May 2015
Environmental Update
for SLEMA Board

Zhong Liu
May 31, 2015

Figure 4: Schematic Displaying Gains from Snap Lake.

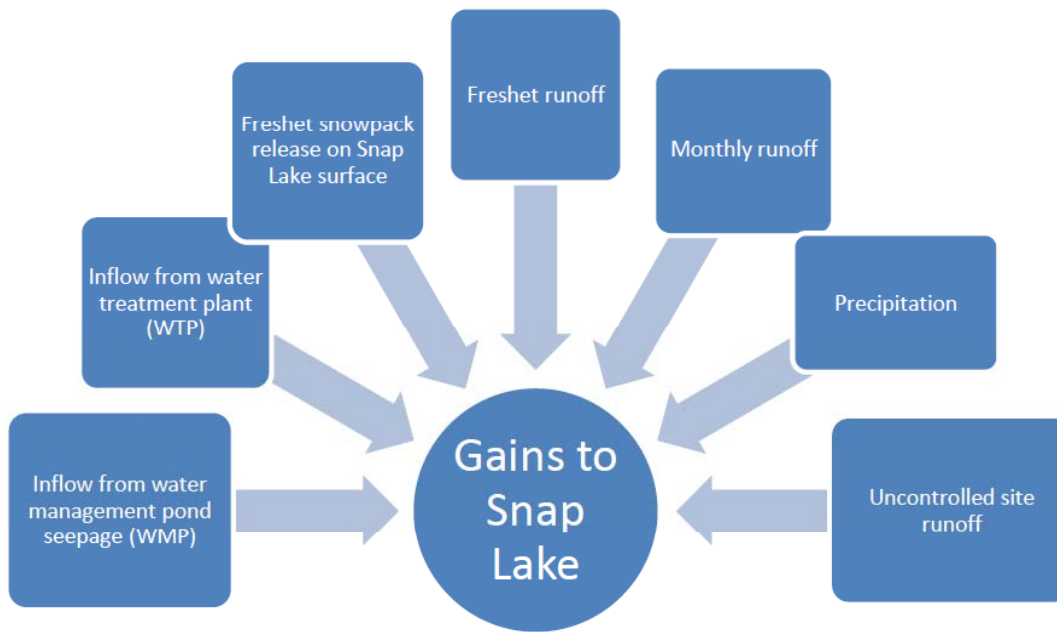
- The inflow from the North Pile seepage is missing Figure 4, whereas it is showed as SE 11 in Figure 5
- Is the Freshet snowpack release on Snap Lake surface part of the precipitation in Figure 4?
- What are the differences among Freshet runoff, monthly runoff and uncontrolled site runoff in Figure 4?
- There are two SE11 in Figure 5. One is the inflow from the North Pile seepage to Snap Lake, another is the losses from Snap Lake via groundwater recharge
 - Correction is requested
